PLANT NAME:
Nine Mile Point Unit No. 1
RJL 7/19/77

NEDO-240(2), NINE MILE POINT UNIT 1 Load Line Limit Analysis LICENSE AMENDMENT Submittal.

Re: Niagara Mohawk Power Corporation
Nine Mile Point Nuclear Station,
Unit No. 1
Docket No. 50-220

APPLICATION FOR AMENDMENT
TO
OPERATING LICENSE

Figure 2.1.1. Flow Biased Scram and APRM Rod Block

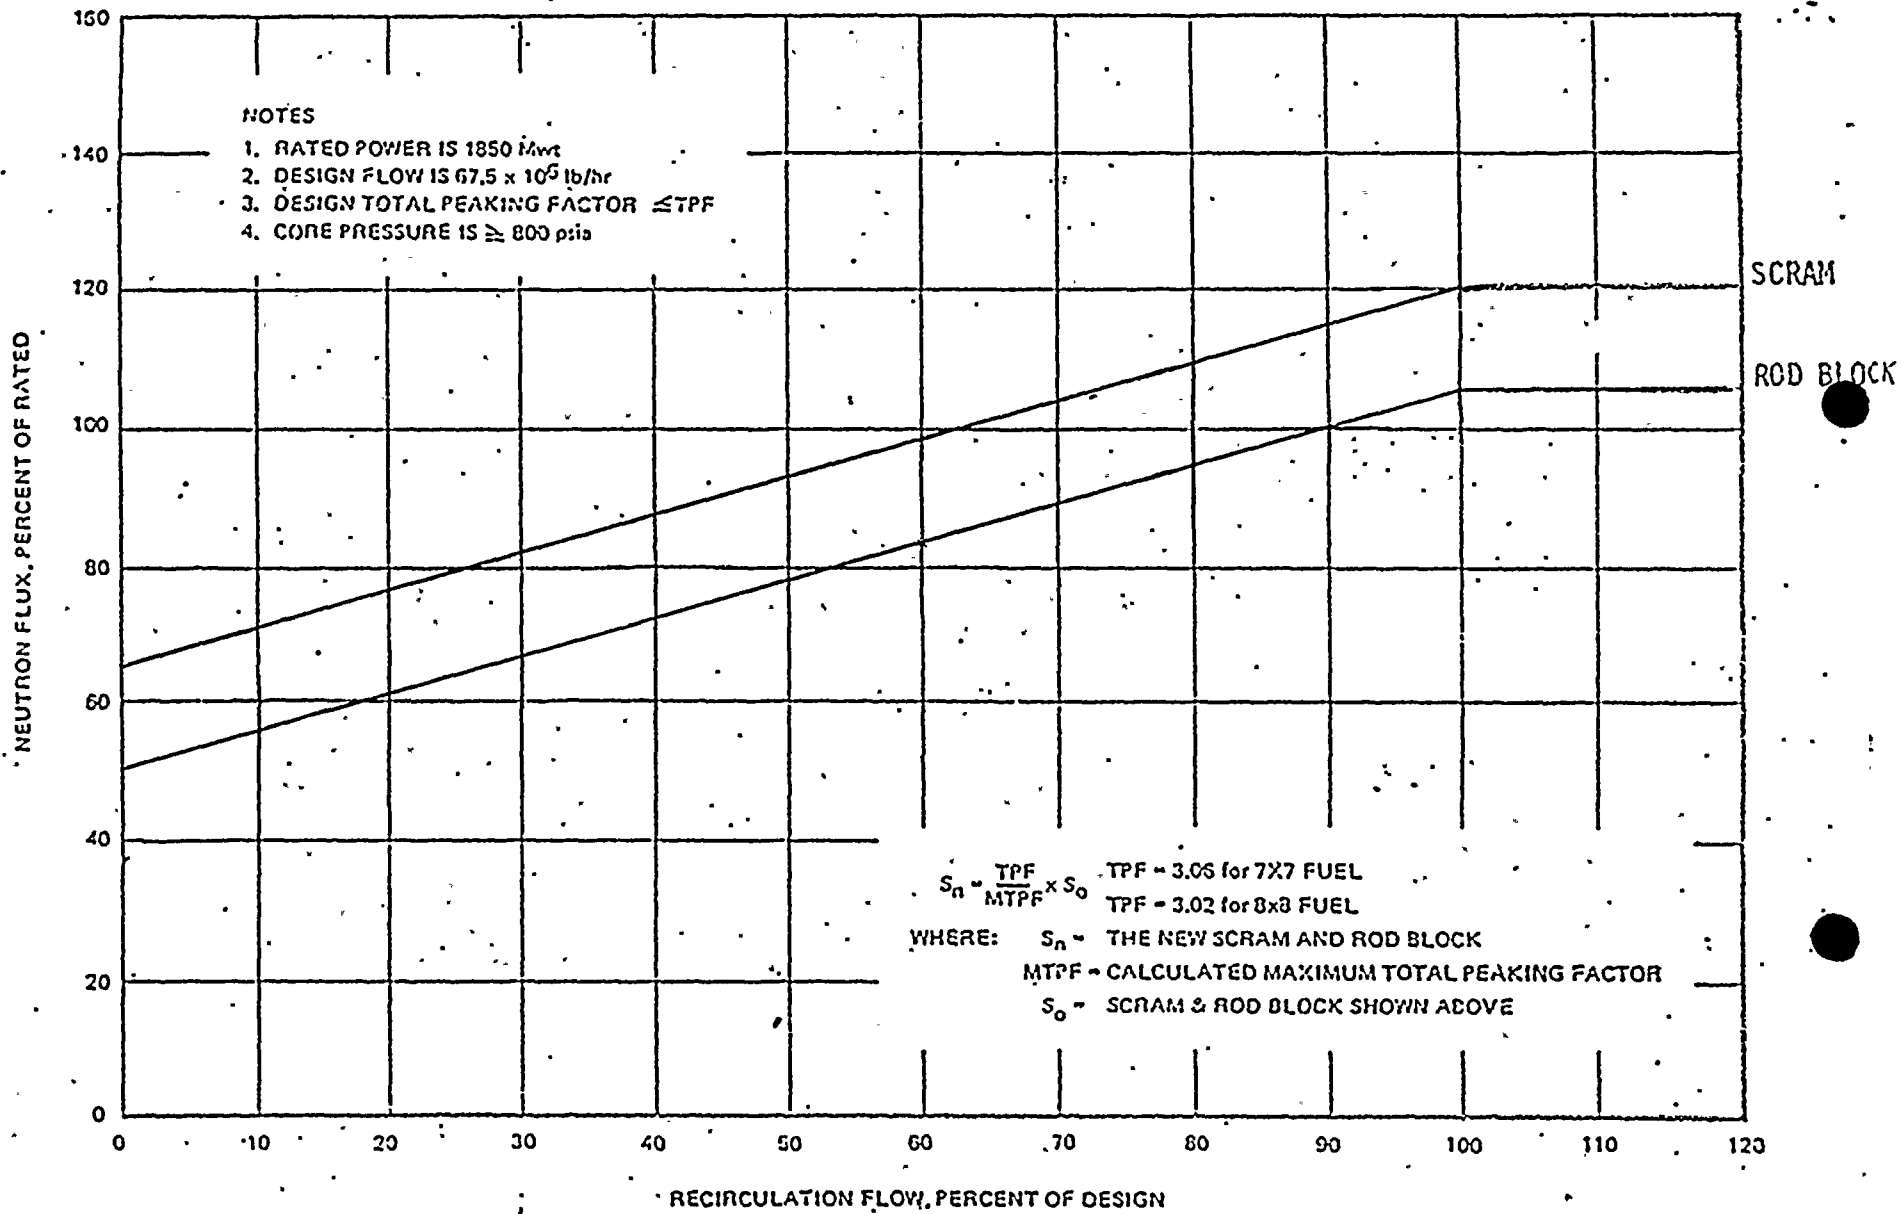
To take advantage of as much of the analyzed envelope as possible, a change is required in the APRM flow biased rod block line and the 120 percent flow biased flux scram line. The current APRM rod block and flux scram lines are overly conservative at low power/low flow conditions. The new rod block and scram lines maintain previously established safety limits.
